From: s 9(2)(a)
Sent: Sunday, 14 June 2020 1:21 PM
To: Barry Wright <Barry.Wright@nzta.govt.nz>
Subject: RE: Query P2W Viaducts

Okahu & Puhoi Viaducts

Deck System Review

16 March 2020

PUBLIC VIADUCT - CENTRE PANEL
 SIMPLY SUPPORTED MODEL

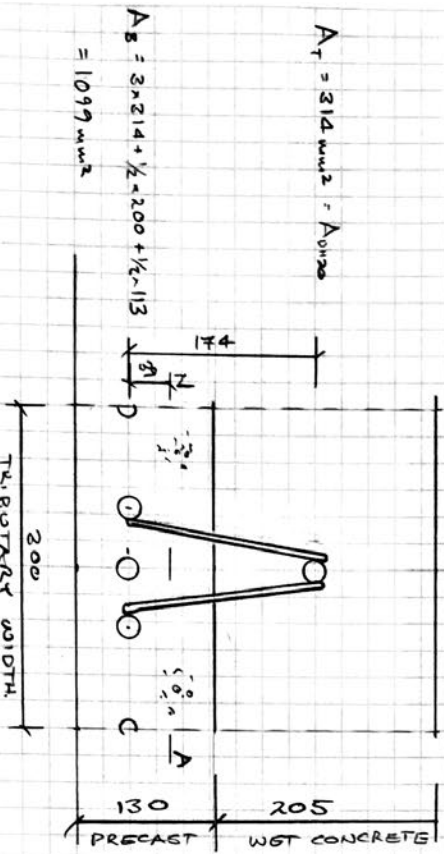
ACTION TO CHECK TOP CHORD COMPRESSION BY AT LEAST TWO INDEPENDENT METHODS.

DETERMINE ALLOWABLE STRESS TO PREVENT TOP CHORD BUCKLING.

$$f_a / F_{all} = 271 / 220 = 1.23 \text{ 23\% OVERSTRESSED}$$

$$f_a / F_{all} = 299 / 220 = 1.36 \text{ 26\% OVERSTRESSED}$$

119% OVERSTRESSED

INITIAL POUR	1.23	> 1.0	NO GOOD
POUNDING	1.36	> 1.0	NO GOOD
2mm MISALIGNMENT	2.19	> 1.0	NO GOOD

COLLAPSE IMMINENT - TOP CHORDS BUCKLE

RECOMMEND ACTIONS INDEPENDENTLY VERIFY

Discipline	STRUCTURAL
Drawing No.	P2Wk-DRG-SE-18-0107
Rev	1

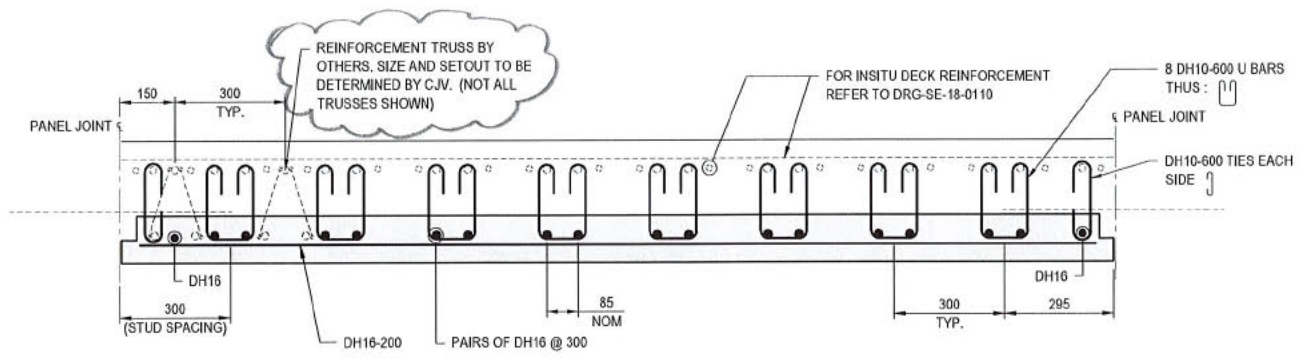
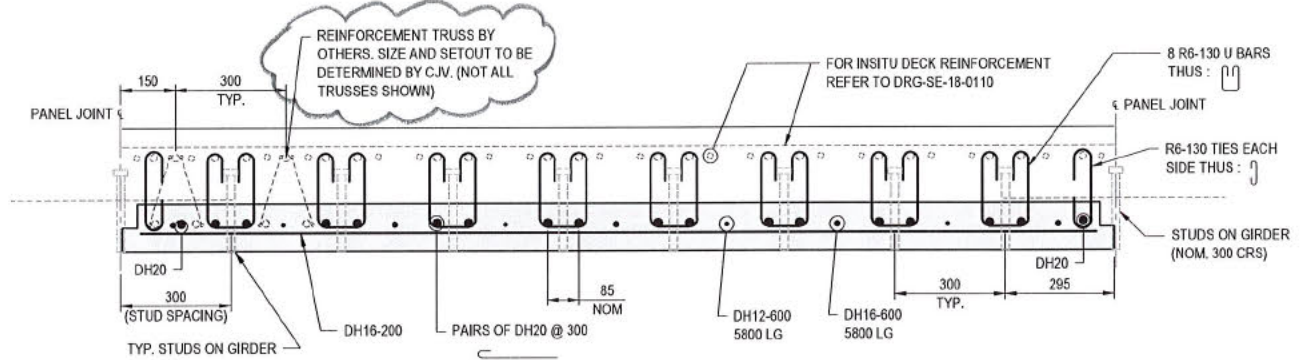
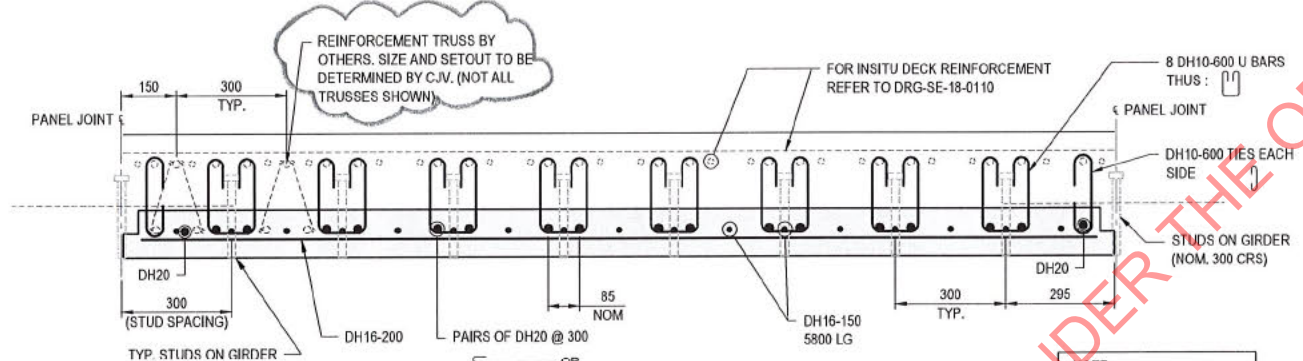
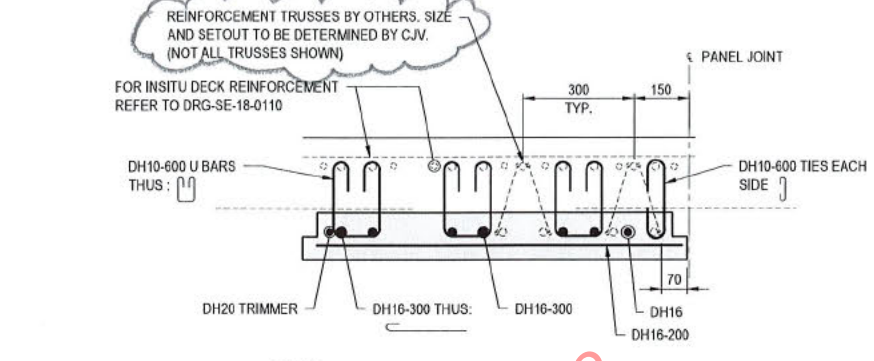
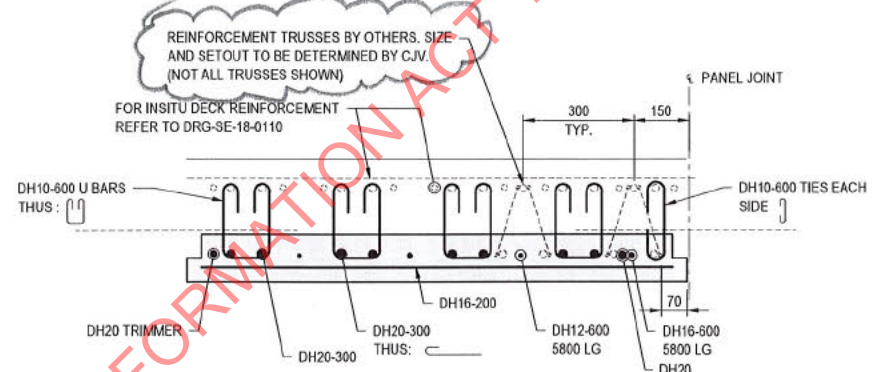
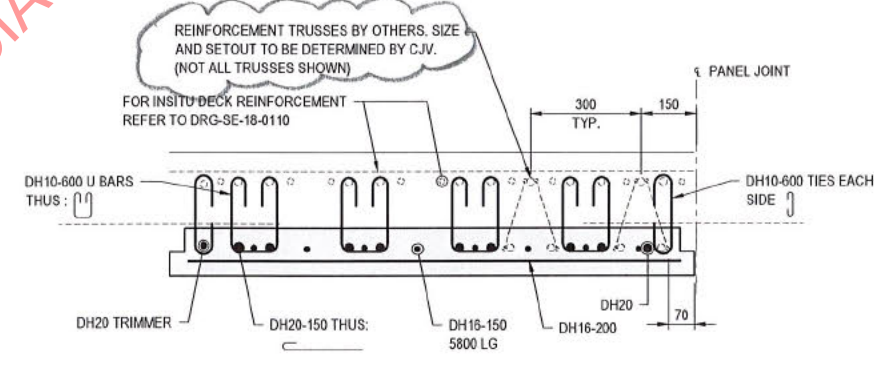
As clearly stated in the construction drawings numbered P2Wk-DRG-SE-19-0107 Rev. 1 and P2Wk-DRG-SE-18-0107 Rev. 1, the TRT's are to remain within the permanent deck and to become 'redundant' during service loading. Due to their welded fabrication they are expected to suffer from fatigue fractures through the chords and diagonals.

- Let us consider the 315mm or 335mm thick permanent reinforced concrete (RC) decks with the TRT's cast within. According to construction drawings numbered P2Wk-DRG-SE-19-0107 Rev. 1 and P2Wk-DRG-SE-18-0107 Rev. 1, Beca consider the TRT's are to become redundant due to fatigue considerations. [REDACTED] agree with this and estimate fatigue fracturing of the TRT's will be within 1 year of opening to traffic. This is based on an assumed fatigue detail classification (which considers the weld embrittlement, eccentricity of between the chord and diagonal creating an abrupt stress riser) and an estimated number of load cycles. The chord stresses due to the cyclic live loads can be compared to the allowable fatigue stress range calculated from the assumed fatigue detail classification and estimated load cycles. The actual stress range within the chords is greater than the allowable fatigue stress range after just one year of traffic.

1. Act urgently and decisively in re-evaluating the deck system as shown on the construction drawings P2Wk-DRG-SE-19-0107 Rev. 1 and P2Wk-DRG-SE-18-0107 Rev. 1, and the two potential failure modes outlined in this report. See Sections 3.1 and 3.2.

2. Request the A ING as TWE to re-calculate the TRT top chord buckling capacity and margins for safety during the work associated with preparing for the topping pour and pouring the topping. It is suggested the tension capacity of the 130 thk concrete precast be ignored in this re-calculation. The nature, probability and consequences of a sudden precast deck failure demand healthy margins of safety. It is recommended they account for some top chord damage in determining buckling capacity to practically reflect reality.

3. Conduct further load testing of the already cast Okahu viaduct precast deck panels. Ensure the panels are accurately supported to mimic loading of the topping pour as accurately as possible. Ensure kentledge offers no lateral restraint to the TRT top chords or provides any top flange effect to authentically mimic the wet concrete topping loading. Test panels with undamaged TRT top chords and those with deliberately damaged or misaligned TRT top chords. Test to failure and note the failure mode. Place kentledge only between the lines of support first; not on the cantilever portion of the outer panels. Record loading and deflections accurately. It is suggested that a professional testing agency or the University of Auckland Civil Engineering school be engaged to assist NX2 develop a thorough load testing regime for the precast deck panels.
